## 1. PCI Engineering Change Notice – PCI-X Card Identification Requirements

<b>TITLE:</b>	PCI-X Card Identification Requirements
<b>DATE:</b>	July 25, 2000
<b>AFFECTED DOCUMENT(S):</b>	PCI-X Addendum to the PCI Local Bus Specification, Revision 1.0, September 22, 1999
<b>SPONSOR:</b>	Dwight D. Riley, Compaq Computer Corporation

**Figure X-2: 32-bit 3.3V Low Profile, Short (Variable Height) and Standard Length Add-in Card with PCI-X Marking**

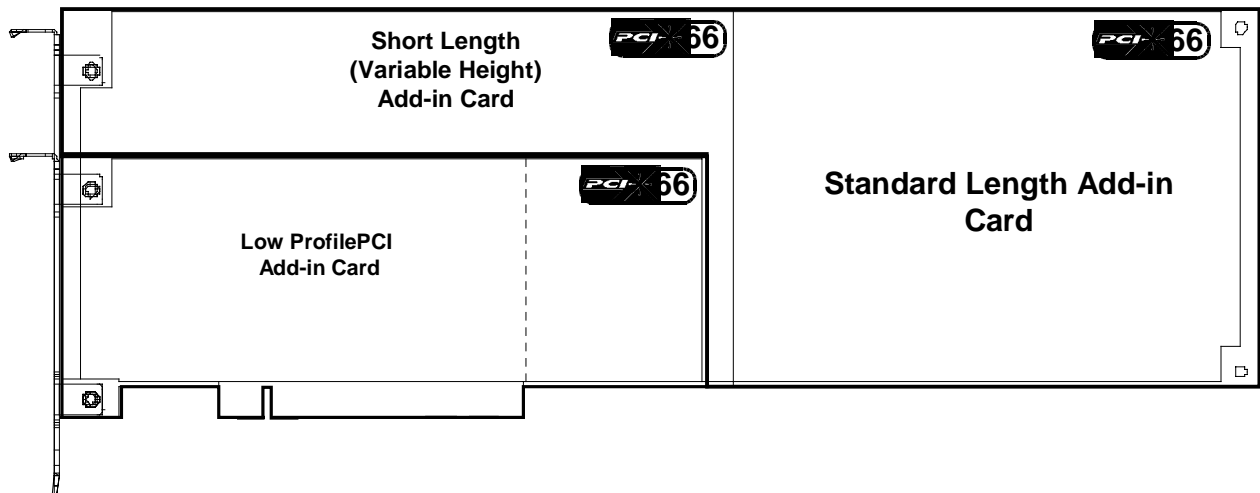
Markings are permitted at any location on either the component side or backside of the PCI add-in card. Marking is recommended to be placed near the top edge of standard length, short length, and Low Profile PCI add-in cards, to allow visibility of the marking when the card is seated in a PCI slot. Figure 4, illustrates placement of the marking while the card is seated in a PCI slot.

Figure 2 illustrates PCI-X markings on standard and Low Profile PCI add-in cards. Figure 3 illustrates PCI-X markings on Type I, Type II, and Type III Mini PCI add-in cards.
